INITIAL FIRE SAFETY INSPECTION REPORT

Glory Textile & Apparels Ltd

RSC ID: 24390

Date: 11 April-2022

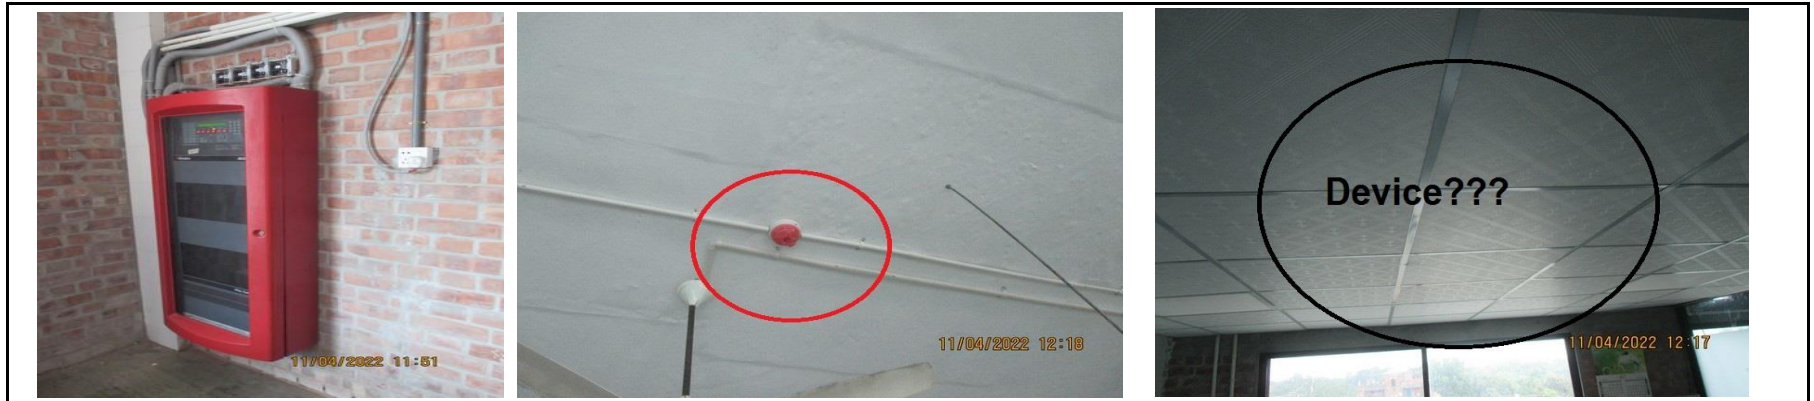
F-6	Fire rated construction	Storage was observed in the corridor on the ground floor between stair-1 to stair-2.	Storage shall be kept clear of combustibles at all times.	Within 1 month
-----	-------------------------	--	---	----------------

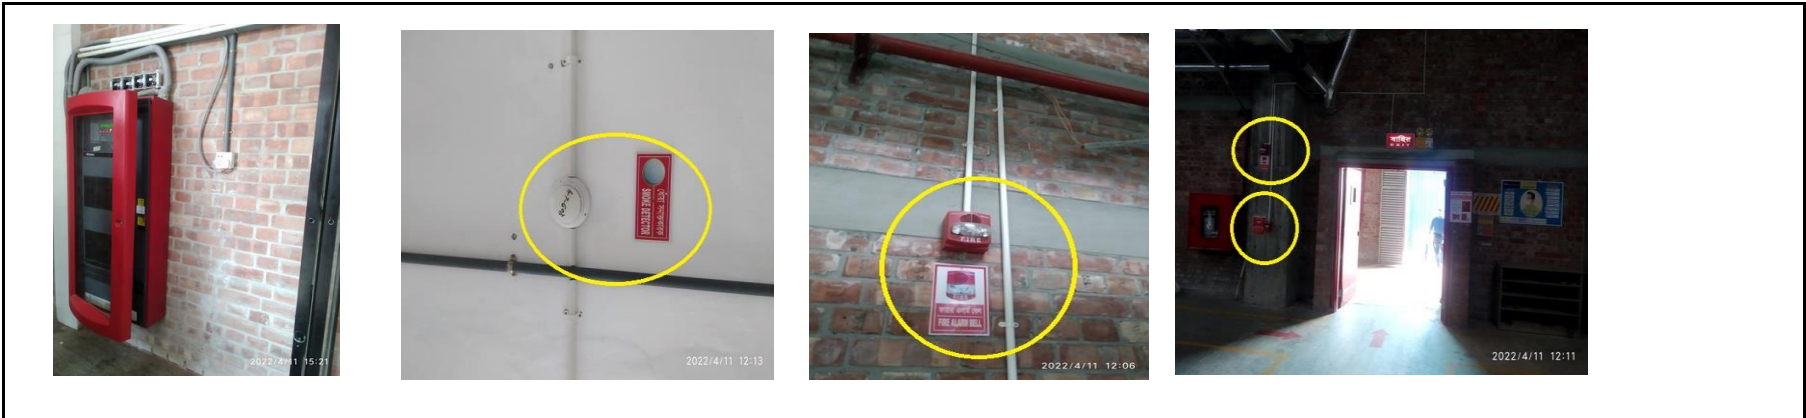
F-29	Mean of Egress	Mean of Egress doors with locking features are provided along egress routes. Egress gates with locking features are provided at building exits and exit discharge.	Remove locking features from all egress doors and gates. If locks are required for security reasons, utilize special door locking features complying with NFPA 101.	Immediately
------	----------------	--	---	-------------
